1. Add Model ID

2. Improved model copy function

Conventionally, only the model data currently active can be copied. In version 3.9, you can copy any model data.

2. CRSF Protocol for TBS

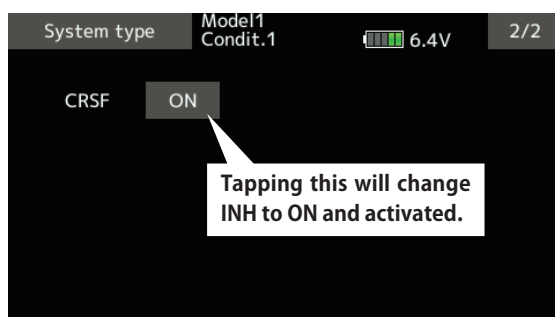
The T18SZ/T16SZ/FX-36 has been made compatible with the CRSF (TBS) protocol.

- ① [Linkage menu] → [System Type] → [Page 2/2] is opened from the transmitter.

- ② Tap the "CRSF" button to [ON]. A signal conforming to the CRSF standard is output from the S.BUS setting connector (S.I/F) of the transmitter.

5. Butterfly Elevator setting (Glider)

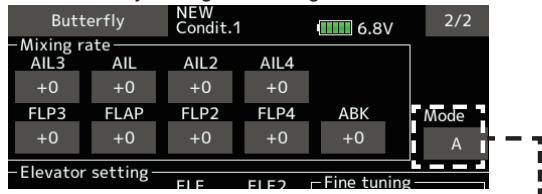
Added fine tuning function to butterfly elevator setting.

6. Butterfly mixing mode (Glider)

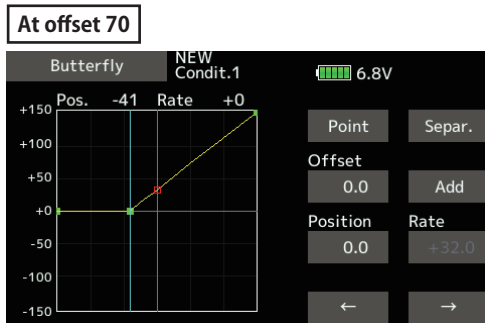
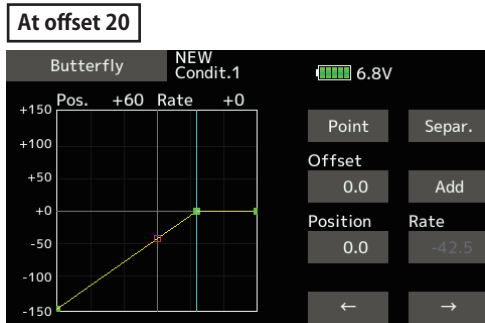
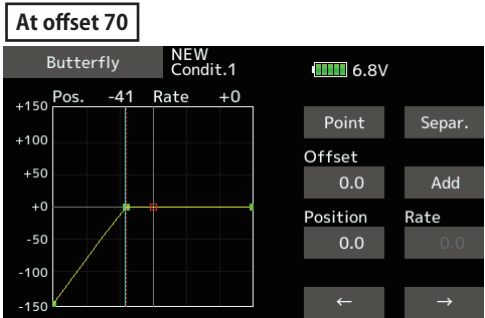
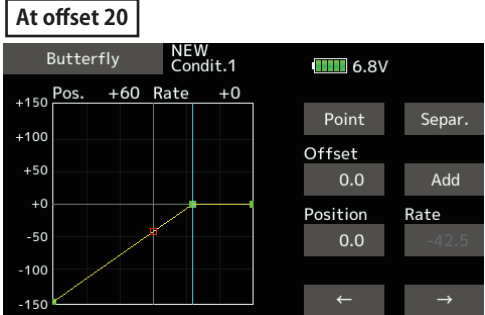
The operation of Butterfly mixing was changed.

Mode A, mode B selection added.

- **Mode A**
(Normal)
- The butterfly operation direction is reversed at the neutral position (50%) of the throttle stick.

- **Mode B**
(Throttle stick full stroke MODE)
- It does not reverse at the neutral position, so you can set the butterfly operation start point with the full stroke of the throttle stick.

5. Fault corrections : V1.6 (GPS Indication)

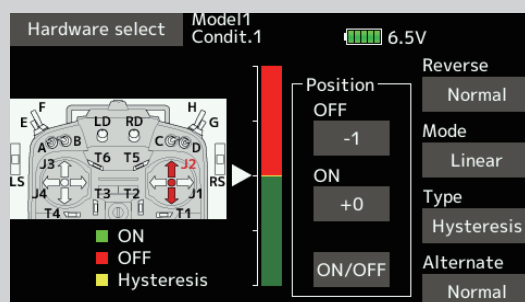
A problem of data from GPS units not being shown was determined on v1.5 software. V1.6 has corrected the issue.

8. Butterfly elevator curve function

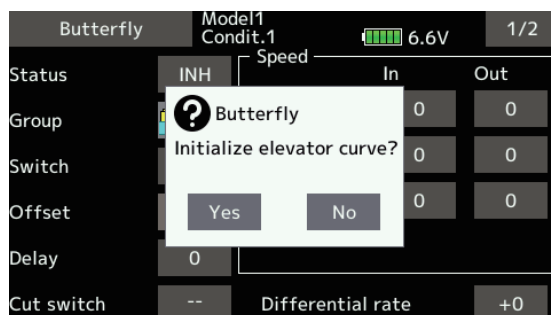
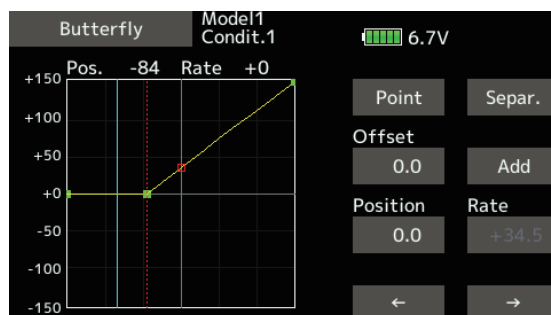
- When offsetting the butterfly operation reference point, operate to the point you want to change and then touch the Offset button. The reference point displays 0%. When [Yes] is touched, the reference point is changed. Then, "Initialize elevator curve?" appears, allowing you to confirm your setting.

- The offset position is indicated by a red dotted line by an elevator curve.
